KG/RL/P6359 20 September 2018

THE COACH HOUSE, 50A BELSIZE SQUARE, LONDON, NW3 4HN

LETTER OF OBJECTION AGAINST PLANNING APPLICATION REF. 2017/3348/P (AMENDED SCHEME)

EXISTING PHOTOGRAPH 2 – FLANK ELEVATION OF 50 BELSIZE SQUARE (SHOWING IMPACT AND PROXIMITY OF WINDOWS INLIGHT OF PROPOSED WORKS)

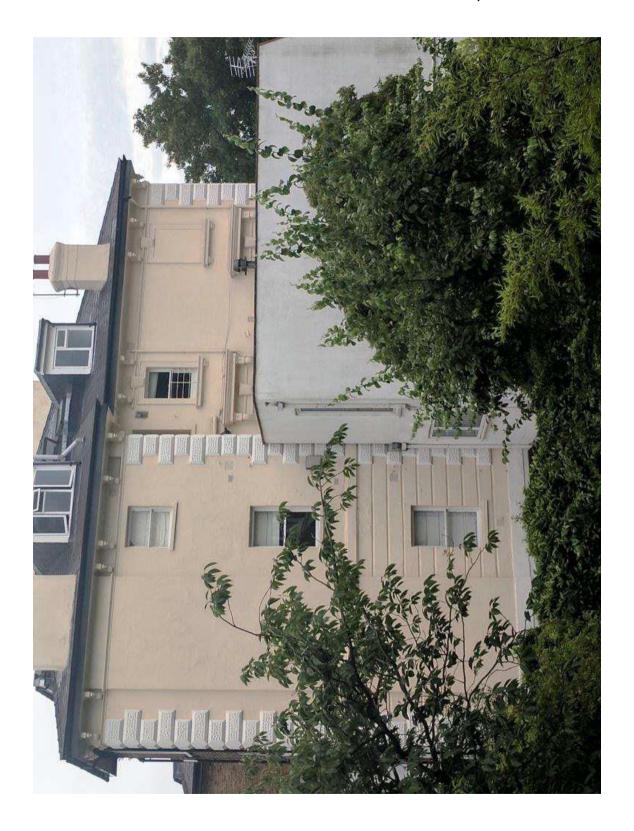
Our Client's property is located on the lower and upper ground floors of 50 Belsize Square which adjoins the application site. Our Client's adjoining boundary to the site comprises the flank wall (western elevation) of 50 Belsize Square and includes two windows both serving bedrooms. At present, issues relating to overlooking and privacy currently exist with unobscured views between the living areas of both our clients and the rear of 50A Belsize Square. Whilst it is recognised that the rear extension has been reduced from the original proposal (mainly due to the loss of the rear glass extension) the location and form of the development will remain in close proximity to our client's bedroom windows, with most impact faced on the Bedroom at Flat 2. This will inevitably heighten those existing privacy and overlooking issues between the two properties and the proposal should be amended accordingly to address the evident issues.

In addition, the retention of ground floor extension and raised walkway would increase the opportunity for overlooking into our client's windows and therefore only serve to exacerbate the issue of privacy and overlooking, rather than improve it.

In light of the above, please refer to the previously enclosed photos which demonstrate the existing close proximity between the application site, 50A Belsize Square, and the bedroom windows of Flat 1 and 2 of 50 Belsize Square.
